SERVICE LETTER NO. 71-13

DATE: December 10, 1971

SUBJECTS: Item 1. Stall Warning Wire Relocation  
Item 2. Master Cylinder Operation  
Item 3. Windshield/Canopy Improvement  
Item 4. Nose Gear Fork Installation  
Item 5. Canopy Attachment Improvement  
Item 6. Prestolite Service Bulletin No. ASM-5

Relocation Instructions (Figure 1.)

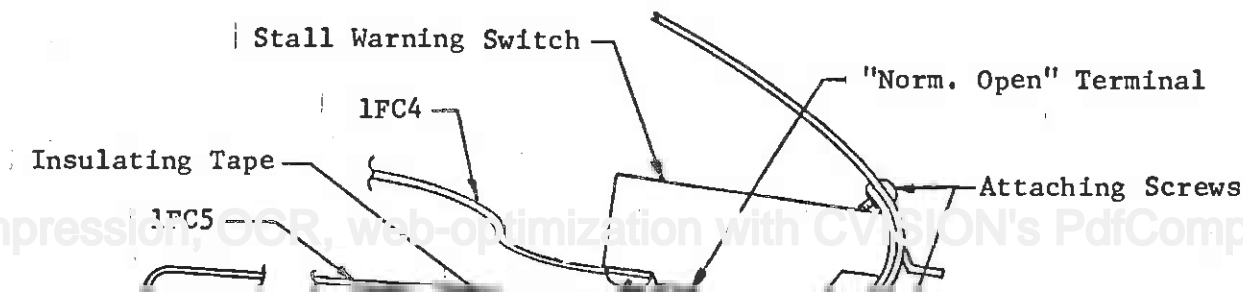
The stall warning switch is installed in the model AA-1A wing such that flexing of the lower wing skin could cause intermittent contact of the normally open switch terminal to the inside of the wing skin resulting in a premature stall warning indication.

To eliminate this possibility, it is recommended that at the next scheduled inspection or sooner at the owner's discretion, the leads on the stall warning switch be reversed so that the 1FC5 ground wire terminal is connected to the "norm open" switch terminal per the following instructions:

1. Remove right wing tip.
2. Mark exact position of stall warning switch and vane in relation to wing leading edge.
3. Remove switch from wing by removing screws that secure switch bracket to wing skin.
4. Reverse 1FC4 and 1FC5 wires on switch terminals so that 1FC5 is connected to "norm open" terminal as shown in Figure 1.
5. Confirm satisfactory condition of insulating tape on inside wing skin.
6. Install switch in exact same position as removed. Install wing tip.

If switch is not relocated in exact same position as removed, the aircraft must be flight tested to confirm that stall warning horn sounds at 5-10 mph above stall speed at gross weight flaps up and flaps down.

Figure 2. Master Cylinder

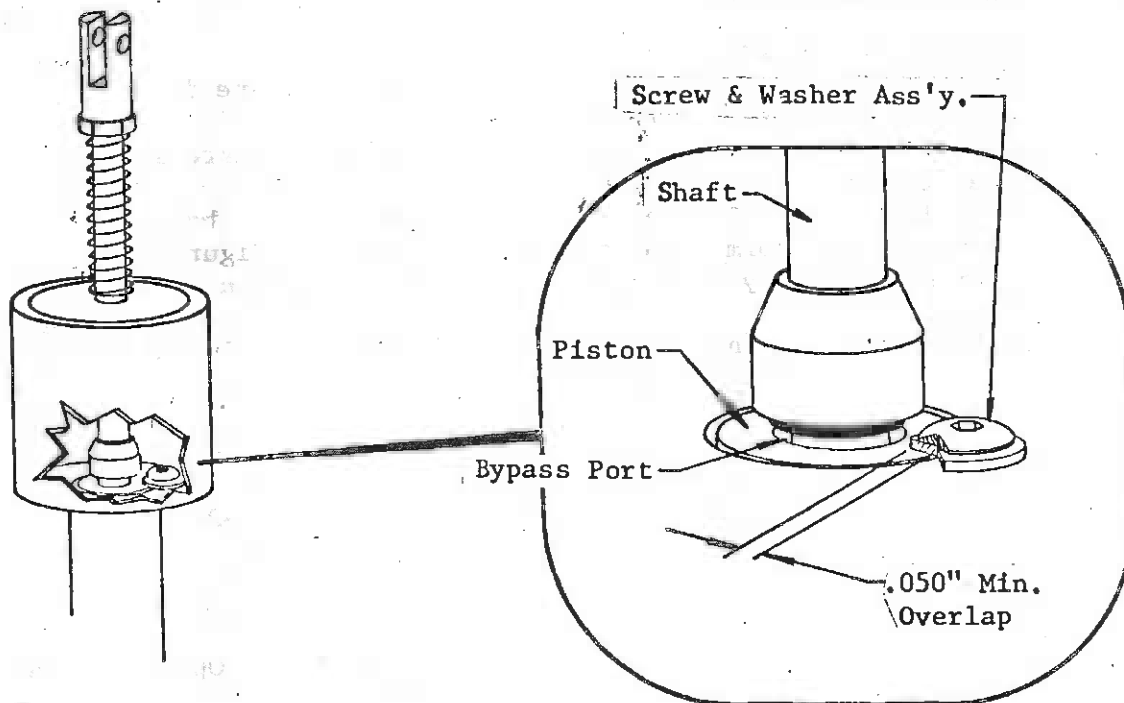
A few field reports of intermittent locking of a brake on the pilot's side of the aircraft have been received. The reports indicate that the brakes will operate normally for an extended period of time, but occasionally one wheel may lock for no apparent reason, particularly after several rapid applications of brakes such as "pumping" the brake pedal.

A cause for this intermittent brake locking has been traced to a slightly mislocated Gerdes part no. A-087-A screw and washer assembly which acts as an up travel stop for the piston and opens the bypass port between the piston and shaft when brake pedal pressure is released. Mislocation of the screw and washer assembly too far from the cylinder bore could result in insufficient washer overlap on the piston which could allow the piston to occasionally slip by the washer, and not open the bypass port, causing that brake to lock or drag.

If intermittent brake locking is experienced, the cause should be determined as quickly as possible. Cylinders that do not have proper washer overlap per Figure 2, should be removed from service immediately and replaced with new cylinders part no. 403010-3.

Note that this possible defect applies only to the reservoir type master cylinders installed on the pilot's side of the aircraft and does not affect the co-pilot's side.

Figure 3. Nose Gear Fork

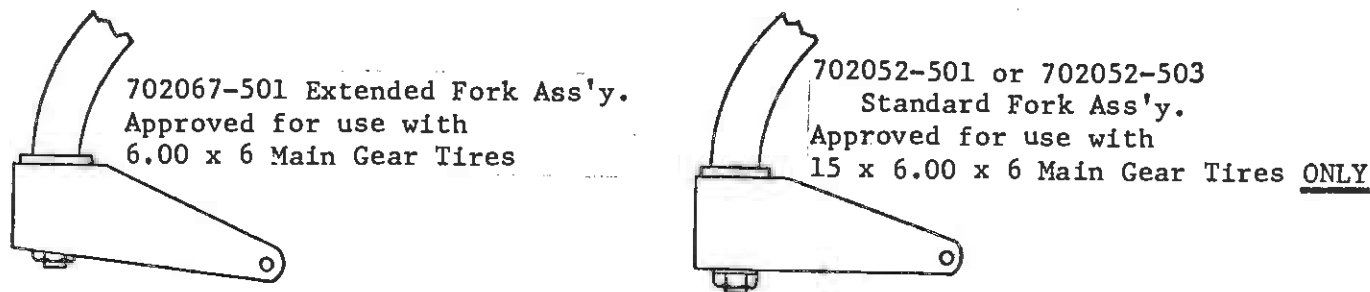
It has come to our attention that some model AA-1 and AA-1A have been improperly modified in the field when replacing the factory installed 15 x 6.00 x 6 main gear tires and tubes with 6.00 x 6 tires and tubes. Those modifications have been accomplished without installing the extended nose gear fork assembly part no. 702067-501 in place of the original factory installed part no. 702052-501 or 702052-503 fork assembly as called out in Accessory Kit No. AK-120.

Failure to install part no. 702067-501 extended fork assembly when installing 6.00 x 6 main gear tires, results in reduced propeller clearance and is not approved. We cannot be responsible for any aircraft operated in this condition. Figure 3 below illustrates the different fork assemblies to assist you in identifying these components.

Figure 4.

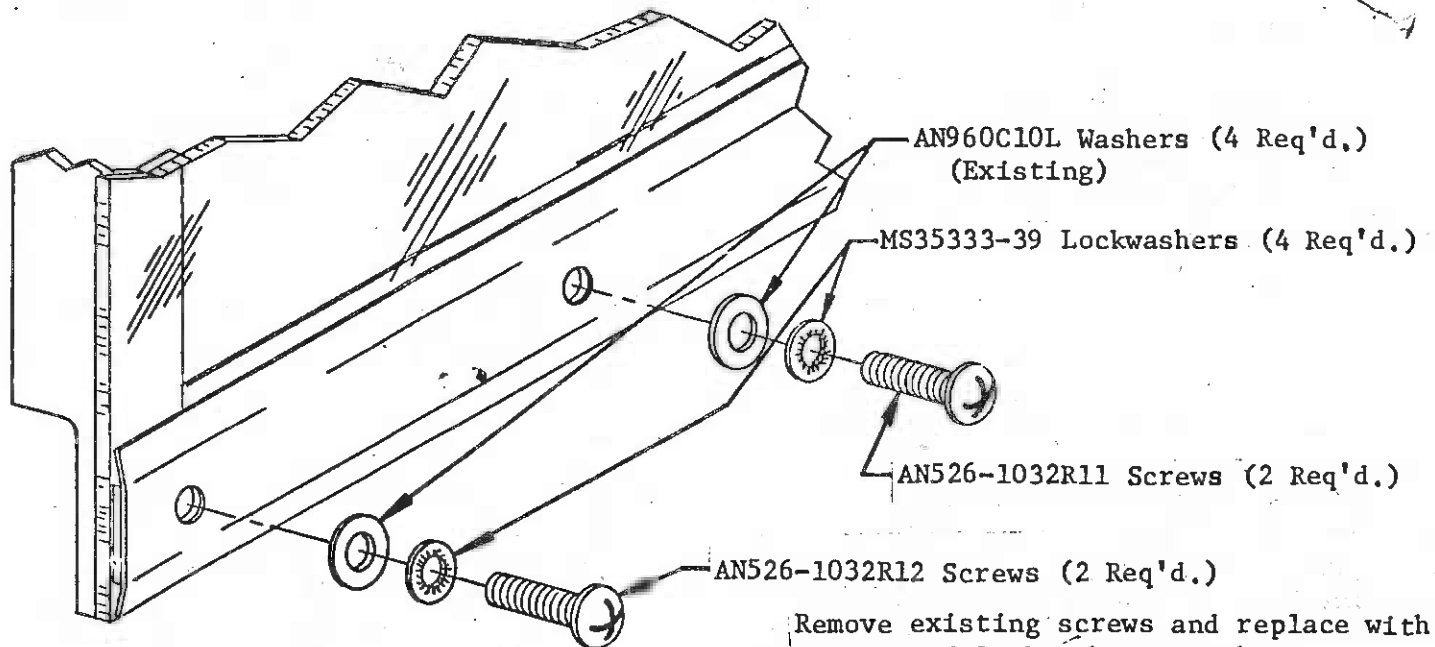
The above aircraft were produced with AN526-1032R10 screws installed in the four lower forward canopy/track attachment holes. These screws were secured to the stainless steel reinforcement inside the canopy track with Loctite.

Effective with aircraft no. AA1-0459 and up and AA1A-0286 and up the Loctite was eliminated, and the hardware changed to increase the screw length and add lock washers to secure the screws.

To prevent possible cracking of the canopy as a result of the Loctited screws loosening in service, it is recommended that the screws on the above affected aircraft be inspected for security within the next 10 hours of operation. If the screws are found loose, they should be replaced with the improved hardware shown in Figure 4.

It is further recommended that the original hardware be replaced per Figure 4 regardless of condition, at the next interval of maintenance that requires canopy removal for cleaning and identification of the tracks.

When tightening any fasteners that secure the plexiglas windshield or canopy, the fasteners should be tightened only enough to insure proper plexiglas retention. Overtightening can cause cracking of the plexiglas.
